A66 Northern Trans-Pennine Project

7.24 Applicant's Responses to the Examining Authority's Written Questions

**7.24 APPLICANT'S RESPONSES TO THE EXAMINING AUTHORITY'S
WRITTEN QUESTIONS**

Deadline:	Deadline 4
Planning Inspectorate Scheme Reference	TR010062
Application Document Reference	NH/EX/7.24
Author:	A66 Northern Trans-Pennine Project, Project Team, National Highways

- EXISTING LEVELS
- PROPOSED LEVELS

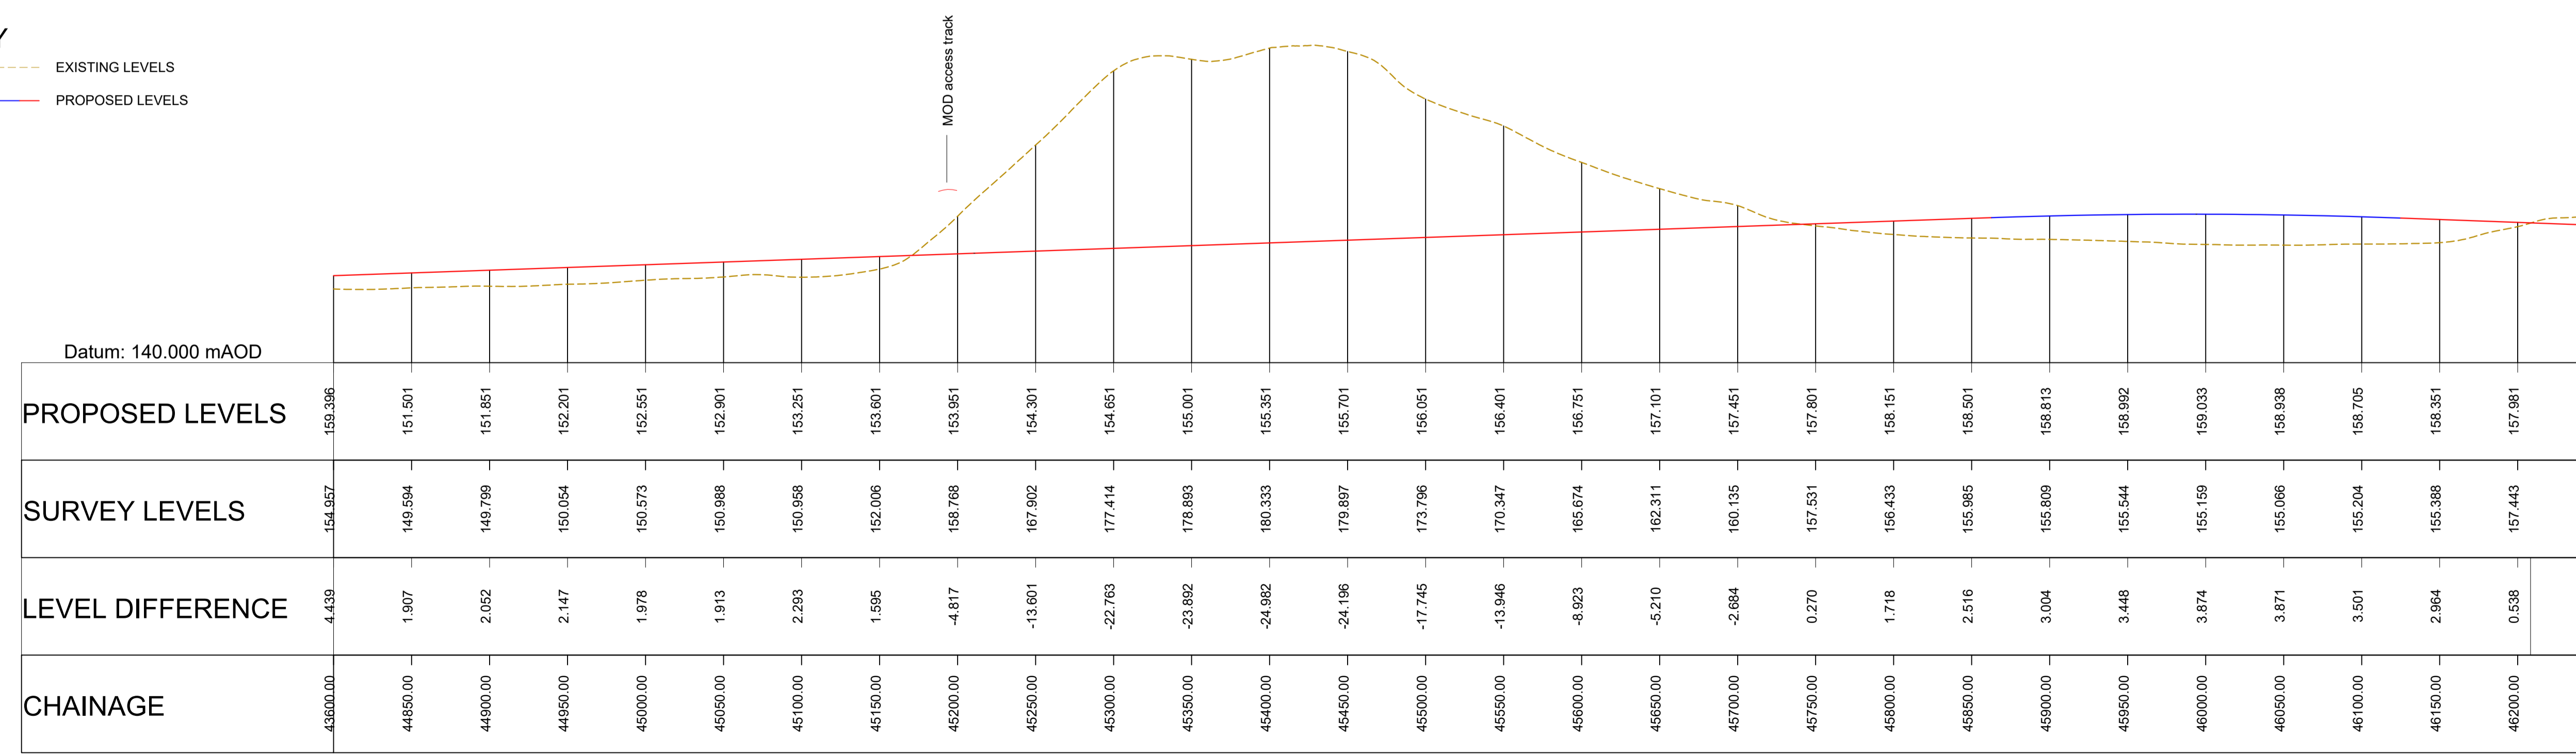
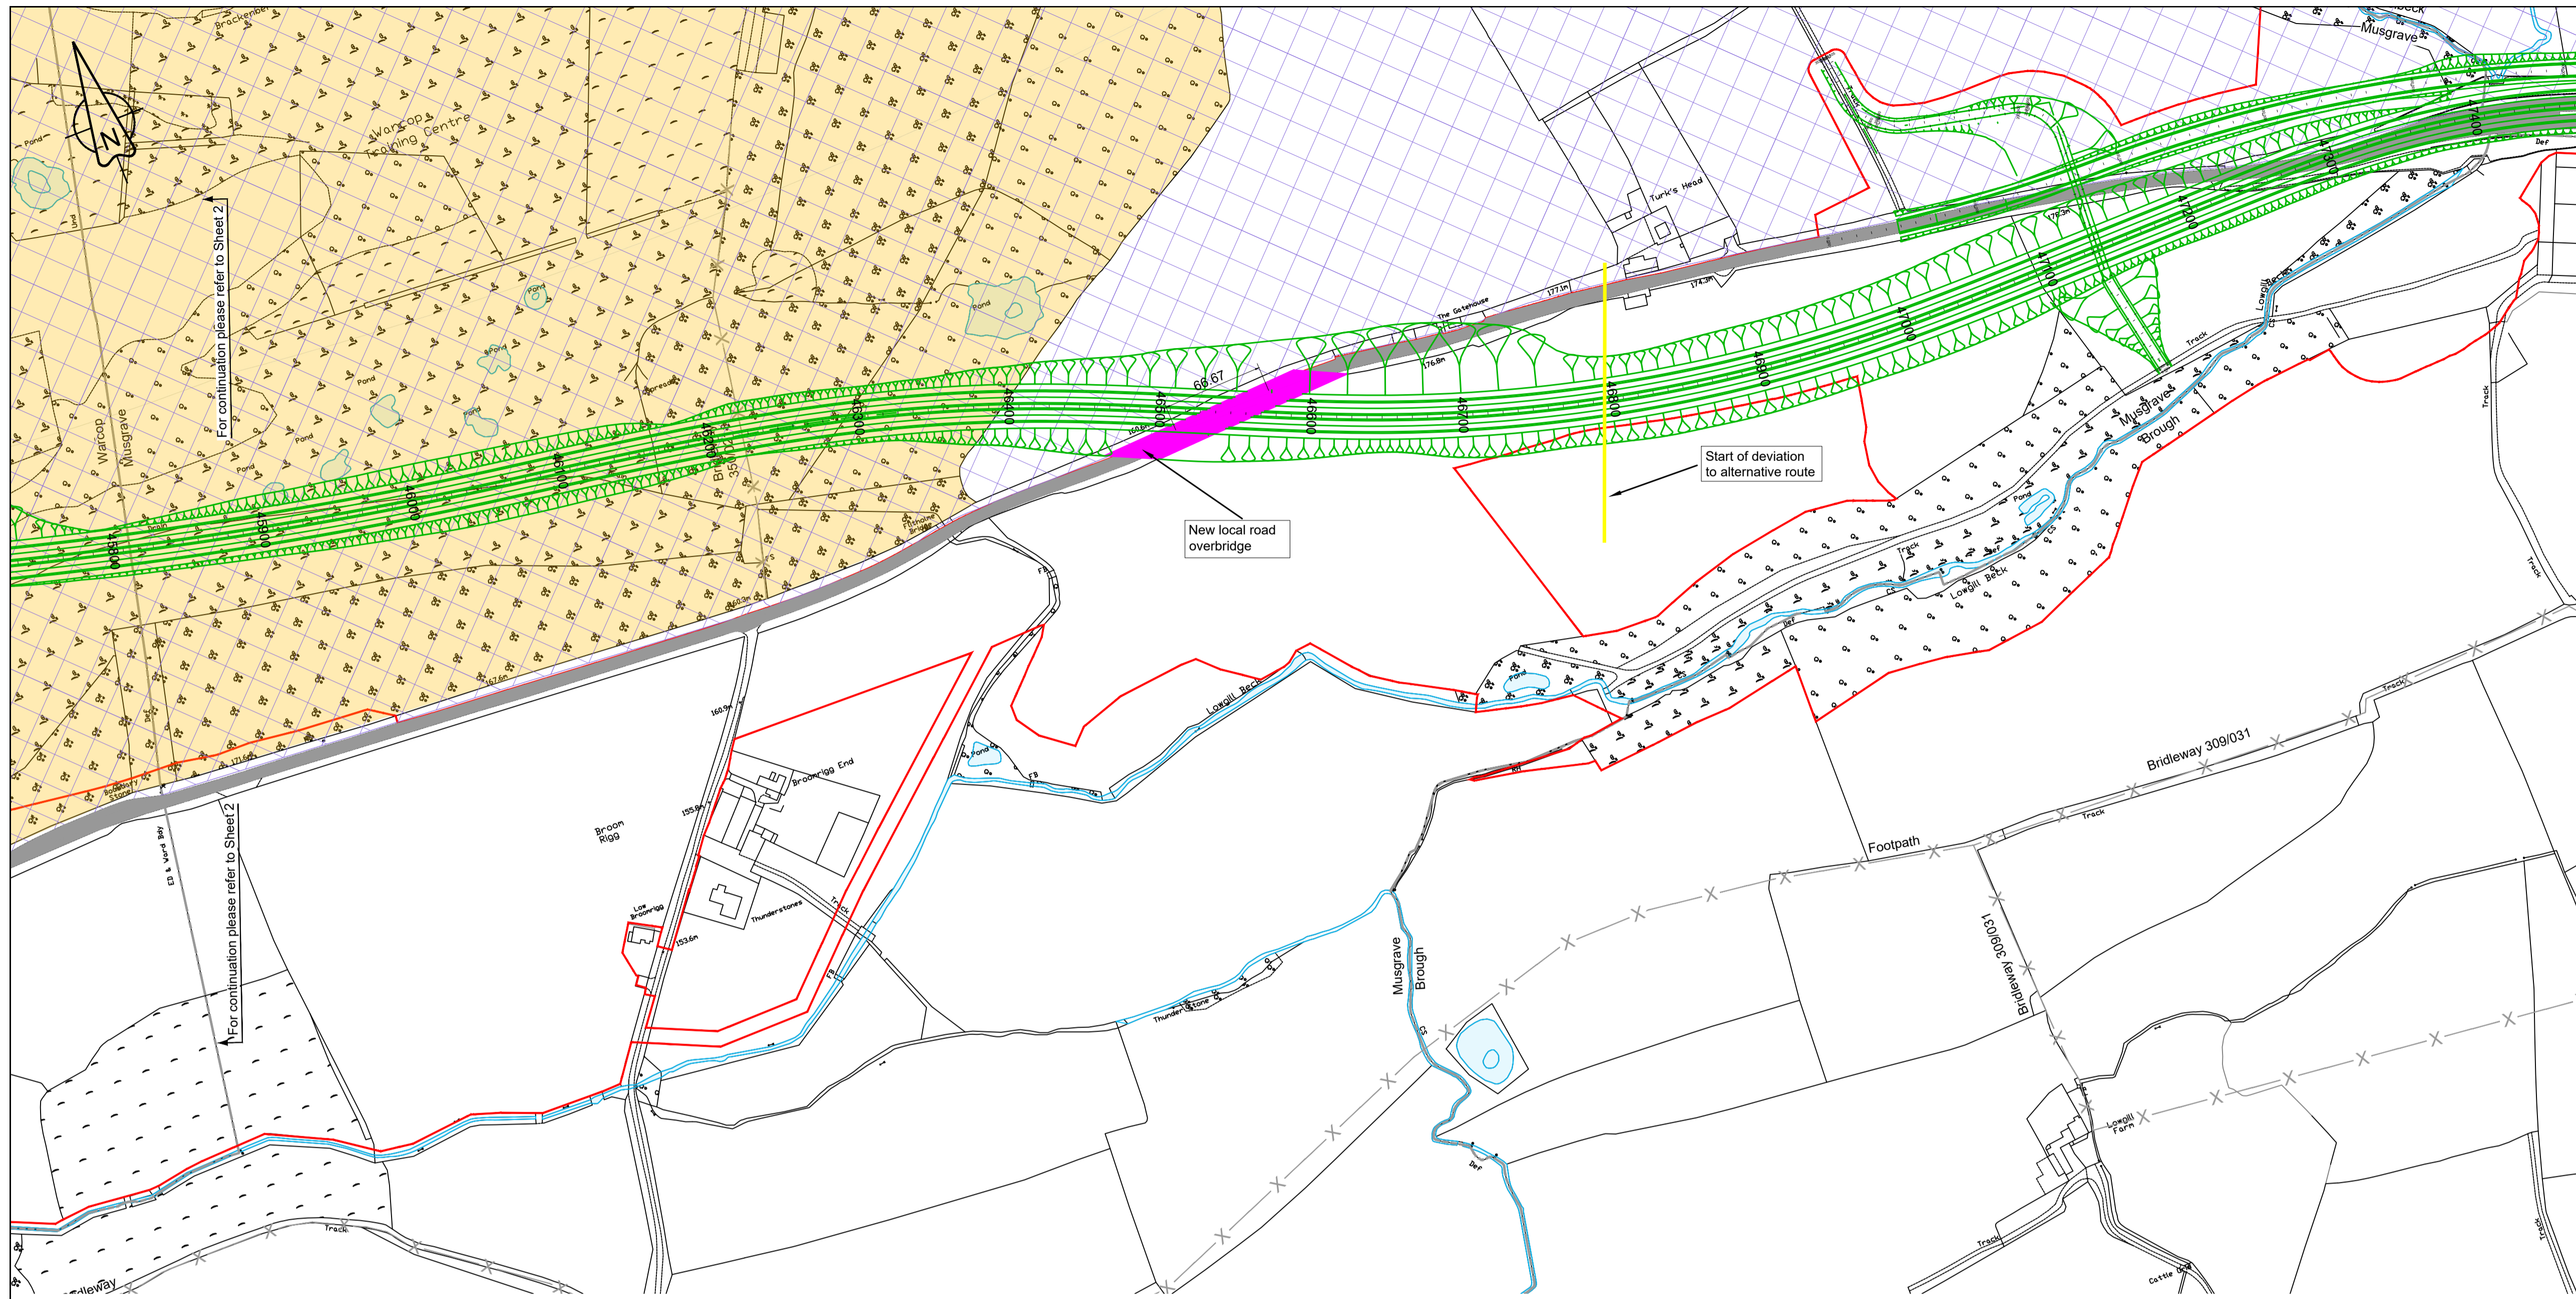
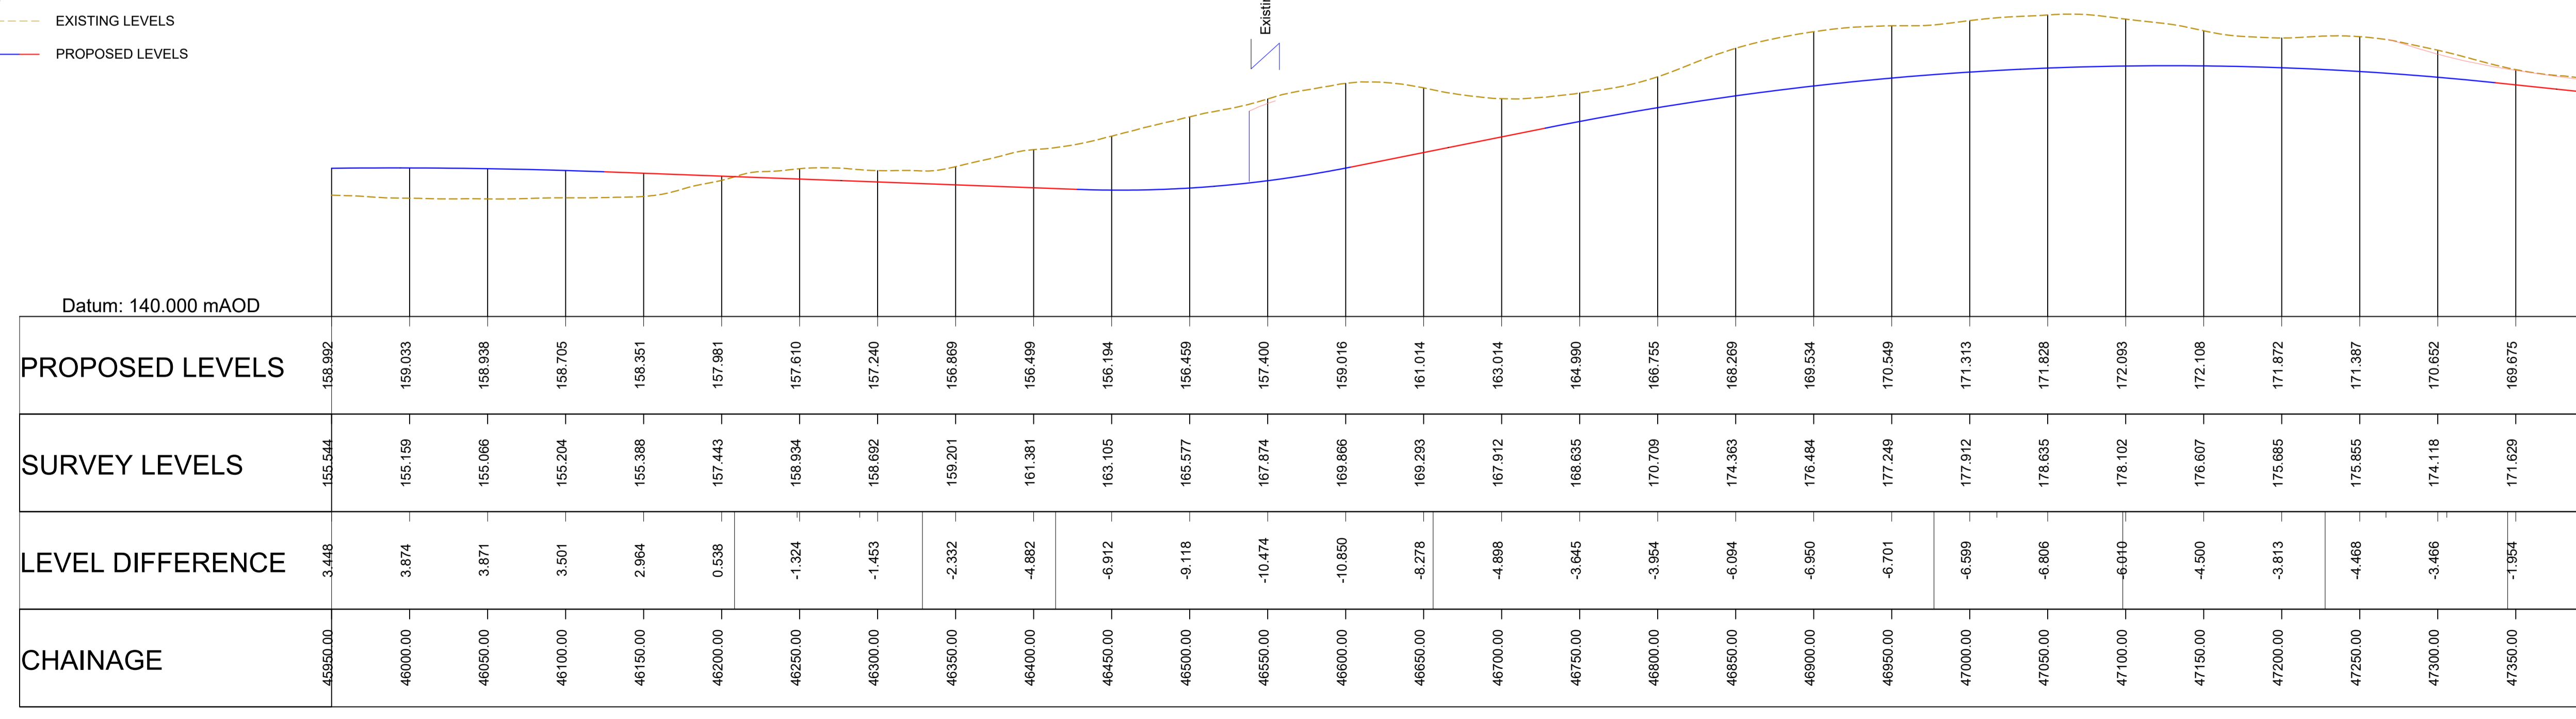
PEOPLE AND COMMUNITIES				
PC 1.1	Brough Hill Fair	<p>Applicant</p> <p>The Representative of the Gypsy and Traveller Community</p>	<p>Several Interested Parties (IPs) make mention of the "Billy Welch straight line route" to the north of the existing A66 that avoids the current Brough Hill Fair site. Provide a plan showing the approximate location of this option.</p>	<p>The Applicant has appended plans to this document, in order to assist with its response to the ExA's question.</p> <p>The first three plans in Appendix C show the approximate location of the "Billy Welch straight line route" against OS background mapping in line with the ExA's drafting request as set out in the Rule 6 letter [PD-006]. These sheets include annotations to highlight key features.</p> <p>The final plan in the set, at the end of Appendix C, shows an unannotated version of the same route against a background of aerial imagery to provide further illustrative context for the route.</p> <p>The alignment shown in the plans has been interpreted from, and therefore considered representative of, a route suggested by Interested Parties.</p> <p>An unannotated plan of this route was discussed during a meeting between the Project team and the local community, including members of the Warcop and Musgrave Parish Councils, in November 2021. As such, those sections of alignment to the west and east of the alternative represent the alignment as it was at that point in time - i.e., the proposals taken to Statutory Consultation. At this meeting, a number of alternative alignments were discussed, including a version of the updated alignment at Sandford now incorporated into the DCO design.</p> <p>Regarding what has come to be known as the "Billy Welch straight line route" (originally proposed by Mr Welch and Warcop Parish Council), meeting attendees were informed that the plan presented did not include drainage infrastructure or environmental mitigation measures, which were expected to be significant given the incursion into the North Pennines Area of Outstanding Natural Beauty. In addition, local topography would require significant earthworks, include large cuttings within operational MoD land, for the route to be constructed (as can be seen on the long sections shown on the plans included in Appendix C).</p> <p>Although this alignment would retain some local accesses, the MoD playing field and the current Brough Hill Fair site, meeting attendees were informed that due to impacts on both the AONB and operational MoD land, the Applicant did not believe this requested alternative alignment to be a deliverable proposal likely to be granted Development Consent. As such, the "Billy Welch straight line route" was not developed or considered further.</p>
